DAWN MINING COMPANY, LLC
P.O. BOX 250
5326 Uranium City Road
Ford, Washington 99013

July 5, 2011

**Re: Revised Proposal for Disposal for Midnite Mine Water Treatment Plant
Solids in Tailings Disposal Area 4**

Figure 2
Illustrative Cross Sections of TDA-4 Remaining Capacity

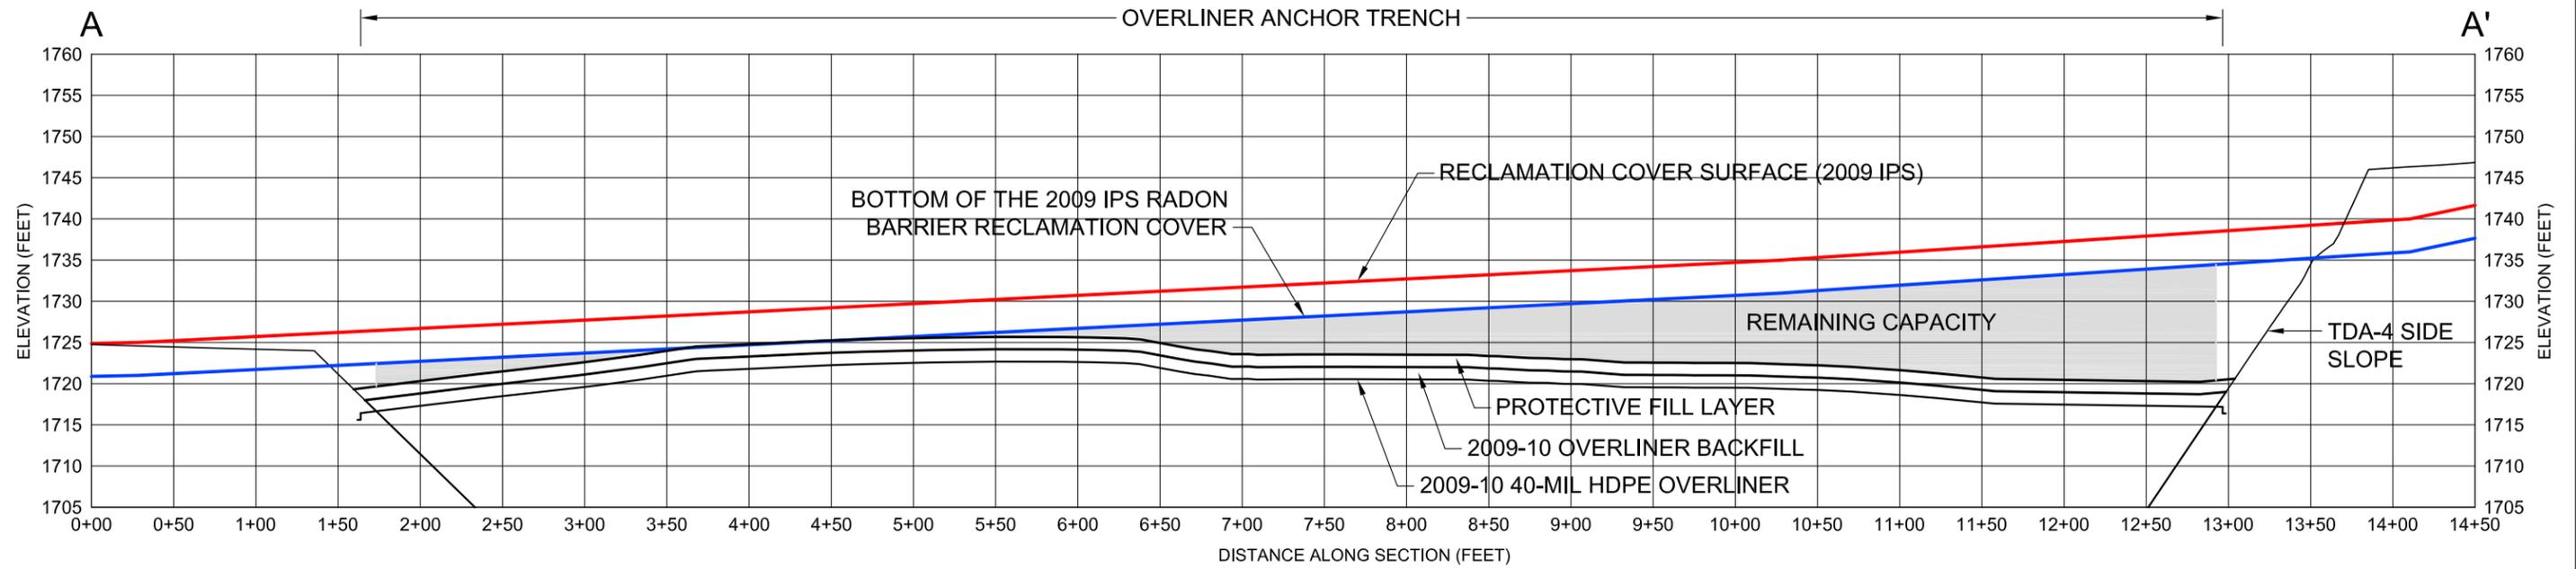
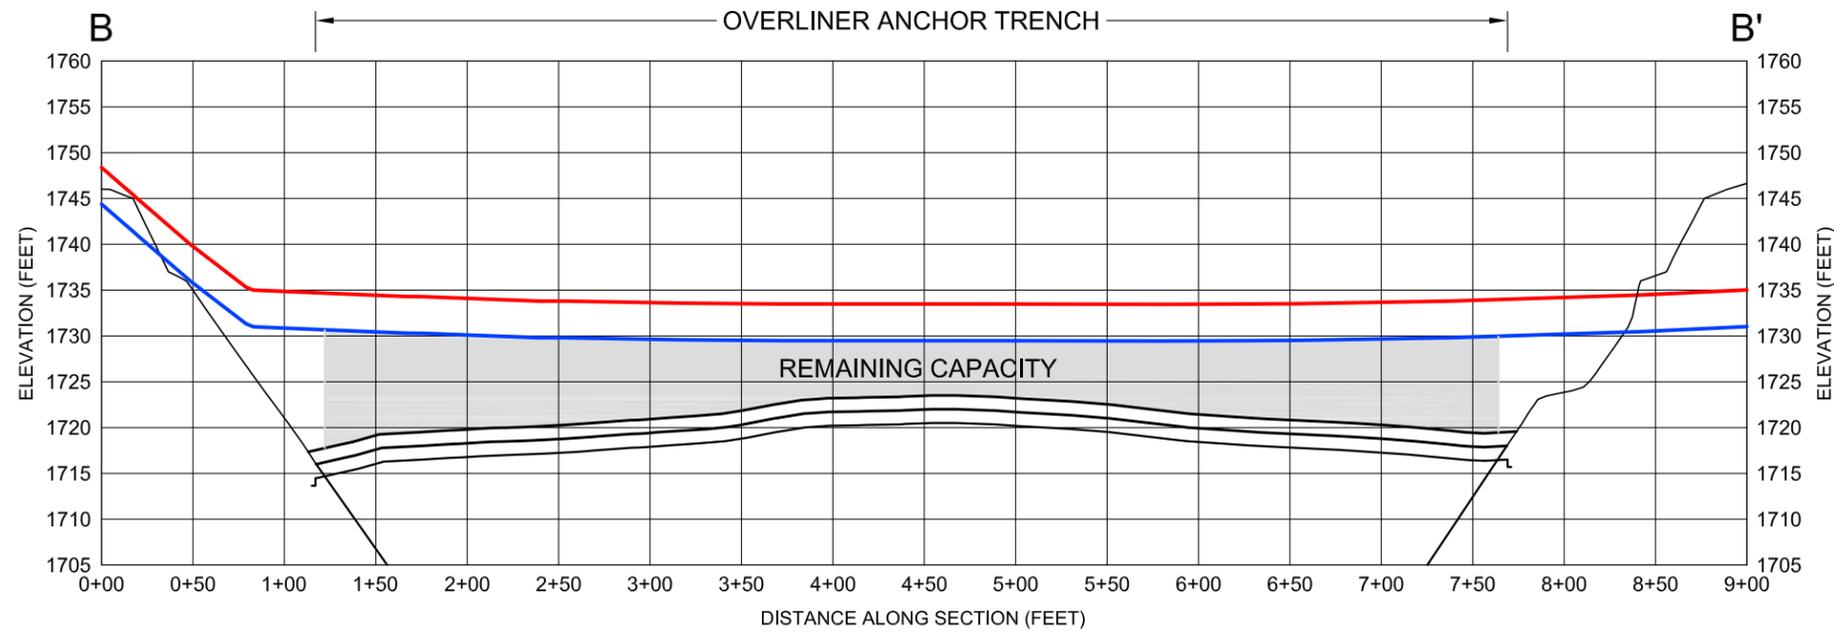
- Figure 2 - Show where cross-sections intersect on each profile.

DMC Response: The cross section locations used in Figure 2 have been located in Figure 1 which is the plan view of TDA-4 in the revised application. See DMC's License Amendment Application, Attachment A.

Figure 3
Schematic Layout of Annual MMWTP Solids Disposal Areas

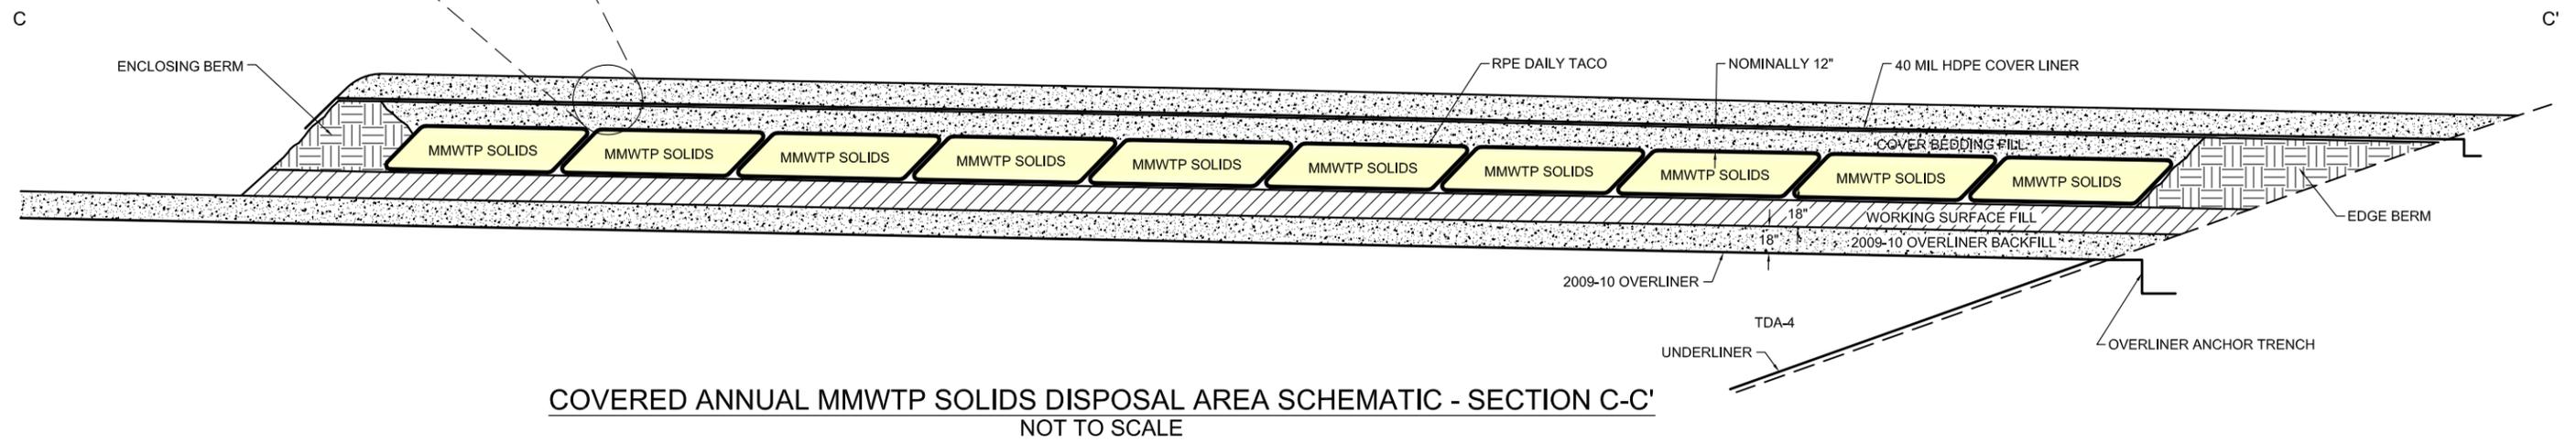
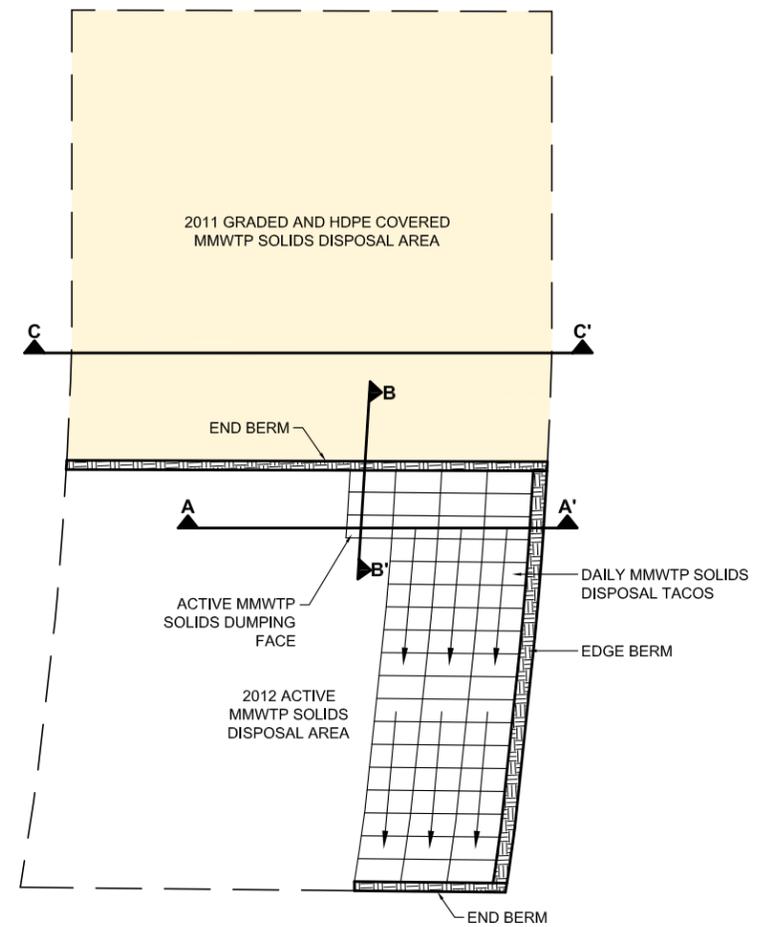
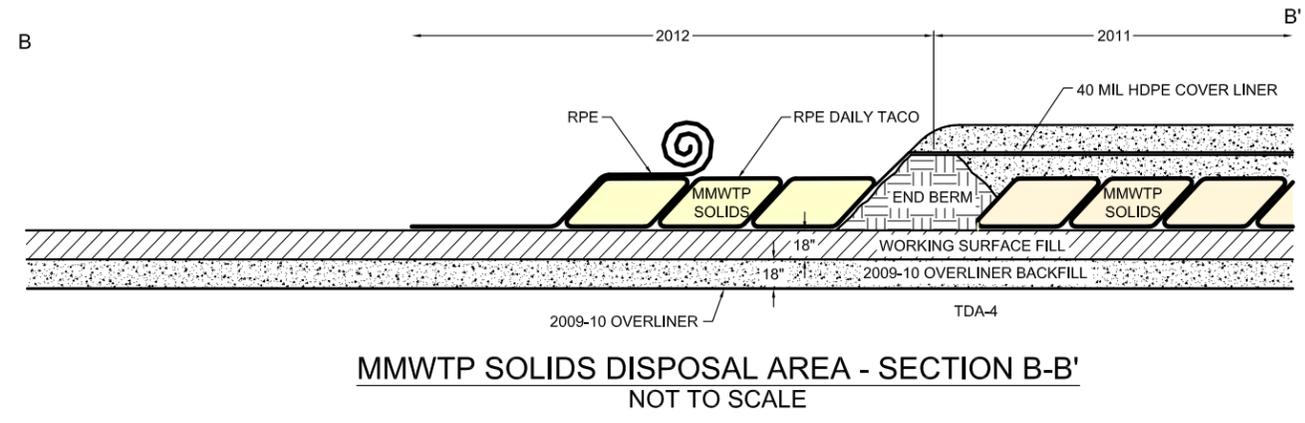
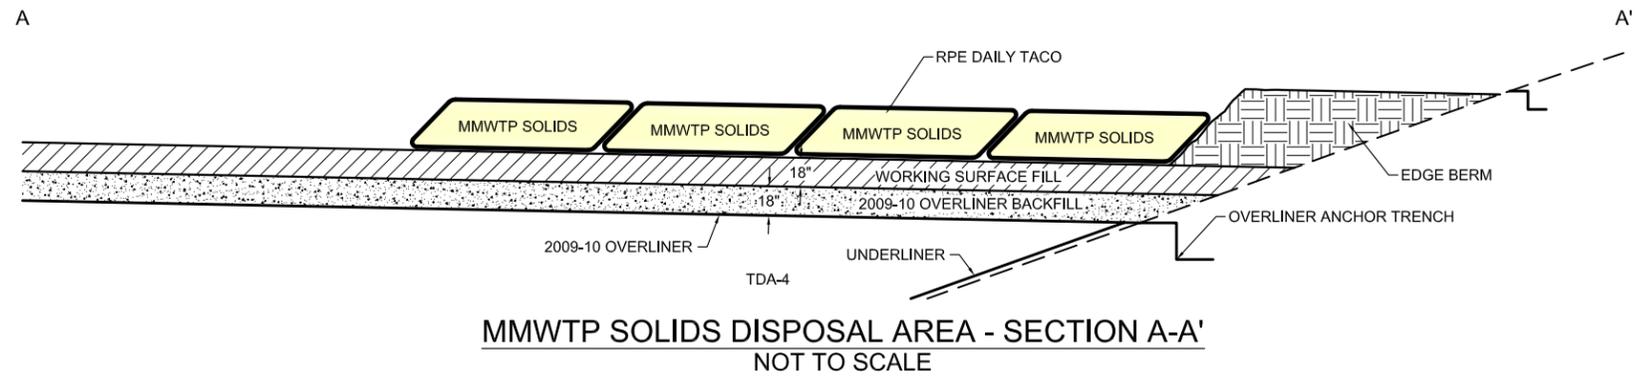
- Figure 3 - Provide a plan view of solids disposal sequencing.

DMC Response: A plan view of the conceptual sequencing of the solids disposal is provided in Figure 3 of the revised application. See DMC's License Amendment Application, Attachment A.

Figure 4 Schematic TDA-4 MMWTP Solids Disposal Area Cross Sections

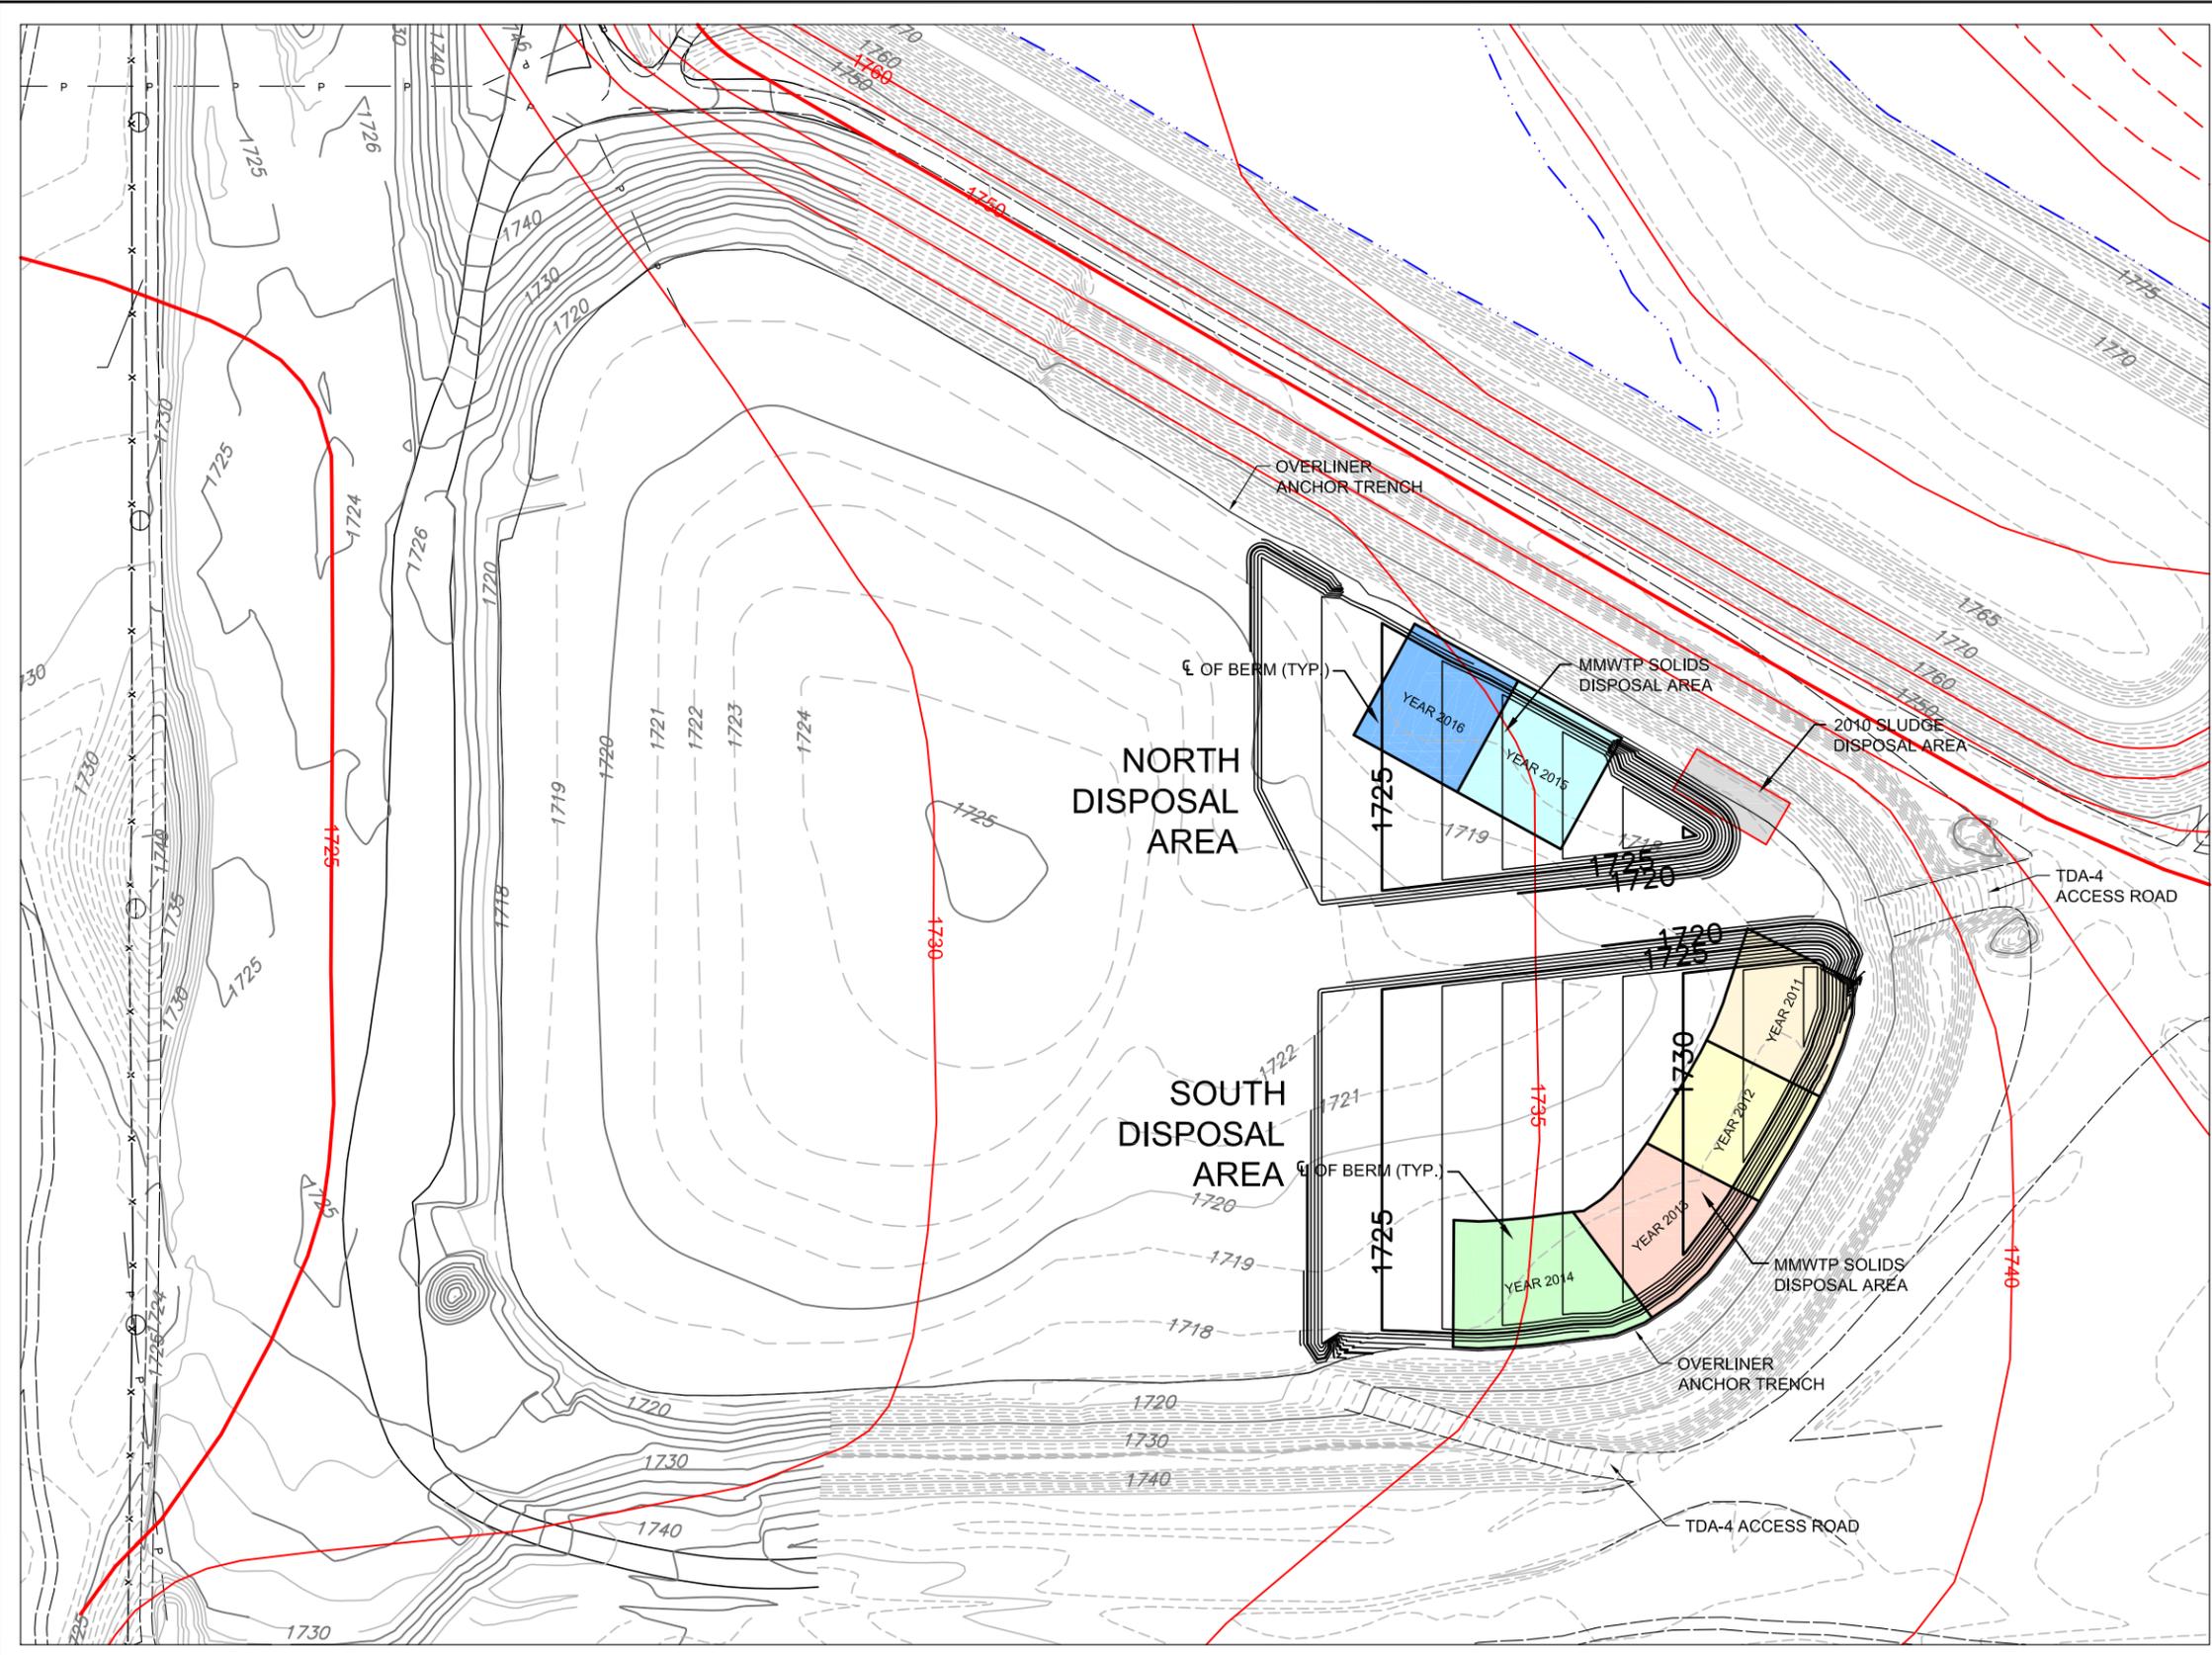
- Annual cover with 40-mil HDPE - soil cover should be added at appropriate intervals, or provide discussion why the soil cover is not needed. (Also needs to be added to DMOP 18a.)

DMC Response: DMC's License Amendment Application has been revised to include covering of the HDPE cover liner with an 18 inch soil layer annually. Figure 4 in the revised application shows the soil layer over the annual cover liner. See DMC's License Amendment Application, Attachment A.
